**Subject: MHI's Revised Response to US-APWR DCD RAI No. 311-2347 Revision 1 (SRP 15.04.06)**

MHI's Revised Response to US-APWR DCD RAI No. 311-2347  
Revision 1 (SRP 15.04.06)

**RAI NO.:** NO. 311-2347 REVISION 1  
**SRP SECTION:** 15.04.06 – INADVERTENT DECREASE IN BORON CONCENTRATION IN THE REACTOR COOLANT (PWR)  
**APPLICATION SECTION:** 15.4.6  
**DATE OF RAI ISSUE:** 4/02/2009

**QUESTION NO.: 15.4.6-5**

**Figure 15.4.6-5.1 Illustration of Boron Dilution Event**

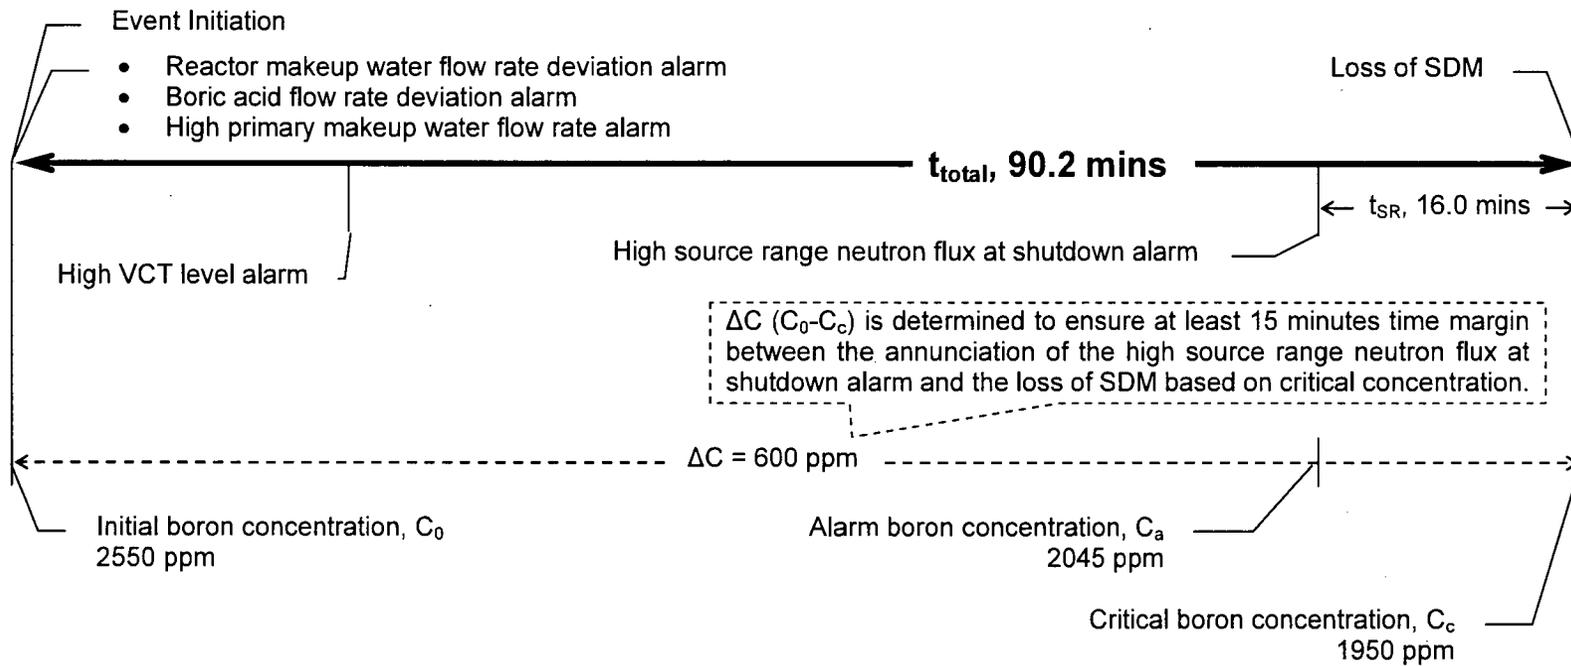
Provide details regarding the calculations done to determine the time available for operator action during the course of the event. Specifically, provide the boron and water mass equilibrium equations utilized.

Figure 15.4.6-5.1 provides an illustration of the overall calculation methodology in these modes that will be useful for the following discussion.

As shown in Figure 15.4.6-5.1, several of the prompting alarms occur immediately at the time of event initiation. Although these alarms are available as prompting alarms, the Chapter 15 analyses conservatively assume the high source range neutron flux at shutdown alarm as the prompting alarm.

The MHI methodology is to calculate the differential boron concentration,  $\Delta C$ , required for each mode based on an assumed time. As indicated in Figure 15.4.6-5.1,  $\Delta C$  is the difference between the initial boron concentration,  $C_0$ , and the critical boron concentration,  $C_c$ . [The SDM will be calculated based on this  $\Delta C$  and is what will be specified in the COLR.] Since the critical boron concentration is known, the quantity of interest is the initial boron concentration,  $C_0$ . Equation (11) can be rearranged to solve for  $C_0$  in terms of  $t_{SR}$  as shown in Equation (12) below.

These values are also shown in Figure 15.4.6-5.1. This calculation shows that an initial boron concentration of 2550 ppm (a differential boron concentration of 600 ppm) is required in Mode 5 to ensure adequate SDM.
